Letter of Objection 15 Crowsport, Hamble-le-Rice, Southampton, SO31 4HG – application no. H/24/96692

Please accept this letter as a strong objection to the above application seeking consent for the erection of a first-floor extension with a roof terrace and single-storey side extension. Our Concerns about planning legislation, precedent, and legal rights, focus on :

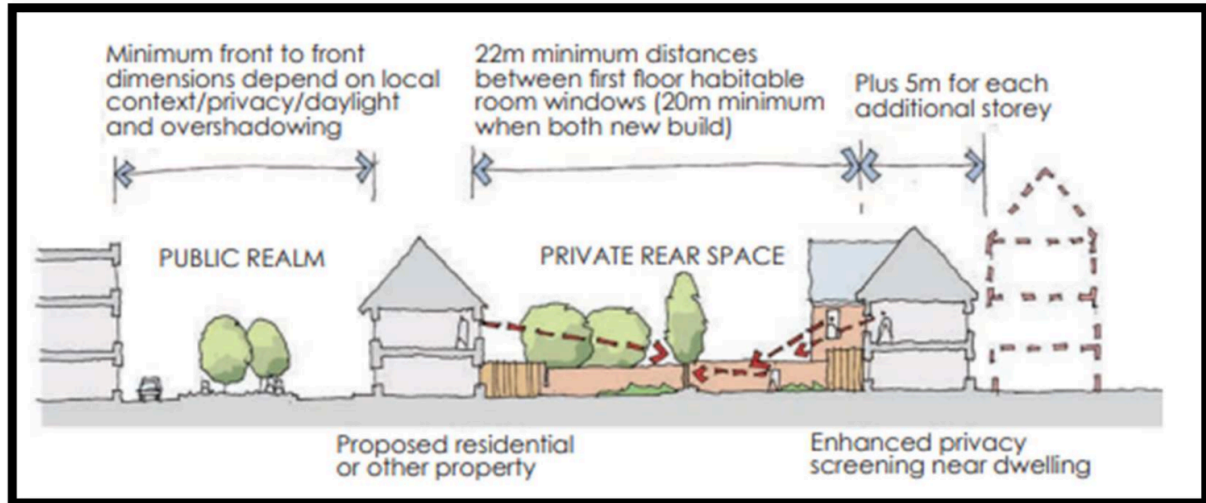
Figure 1 below is taken from the Design Sustainability and Access Statement and demonstrates the extent of the overlooking resulting from the proposed first-floor extension. At its closest, the proposed terrace is approximately 4m from the shared boundary and 5.5m from the closest facing elevation of our property. This elevation contains full-length windows to the two bedrooms and lounge area on our south elevation.

Furthermore, direct views into the ground floor bedrooms on our south elevation from the terrace cannot be ruled out, given the proximity and orientation of the two properties. Indeed our own planning consent (2016) was amended to require 1.8m high privacy screens on the roof terrace “to preserve the privacy and amenity of the adjoining occupiers” and to provide a balustrade along the intended position of the first floor walls to discourage use of the roof until the planning consent was fully implemented.

The loss of privacy would be most acute in the lounge area and south-facing garden with the full-height glazed wrap-around windows potentially leading to views of the occupants of that room and in turn views back to the roof terrace.

Distance from 15 Crowsport terrace to 16 Crowsport living room sliding window 22m

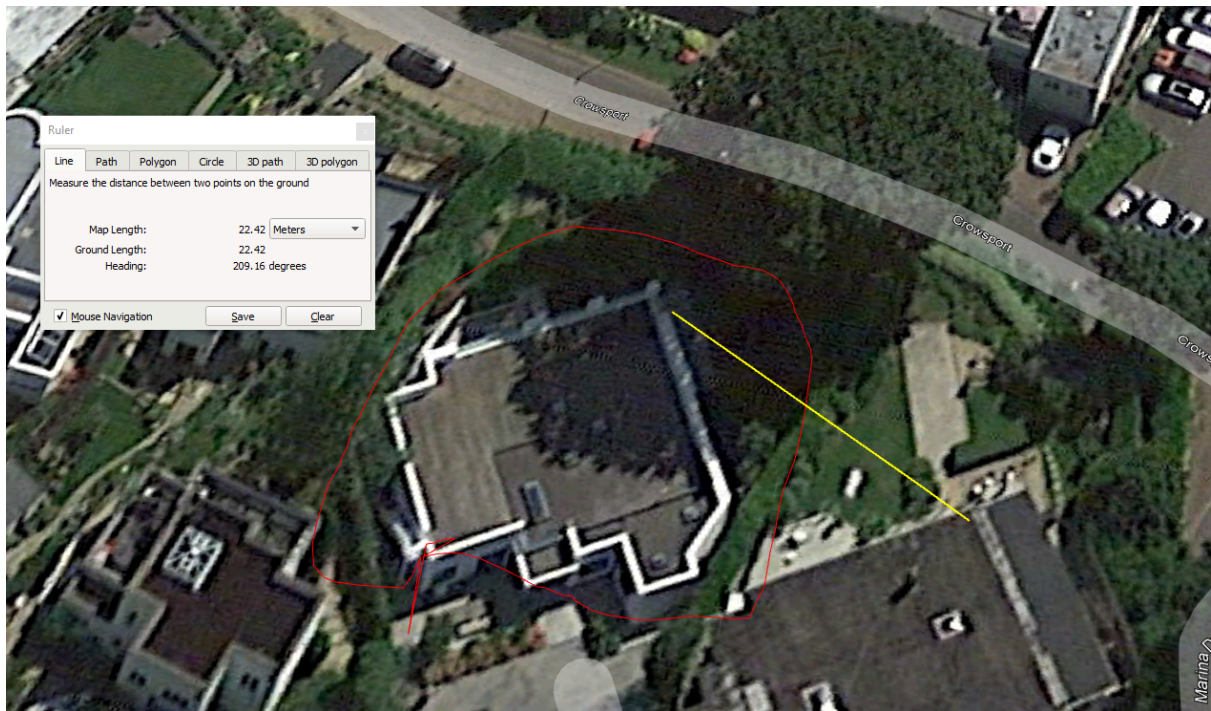
The development clearly fails to meet minimum privacy distances in this regard and it will result in overlooking no 16 Crowsport. It is noted that the applicant's design statement includes photographs of the wider area but not of the direct context of No's 15 and 16 side by side, or as viewed from the river, given the prominence of 15, 16 and landmark oak tree

Of the many obvious impacts of such close proximity - including loss of privacy is the significant increase in ambient light from both the balcony and habitable 1st floor - this will in essence introduce a new night light impact onto both the garden and dining area externally and the living room internally. We suggest restrictions on fixed night lighting on any future terrace.
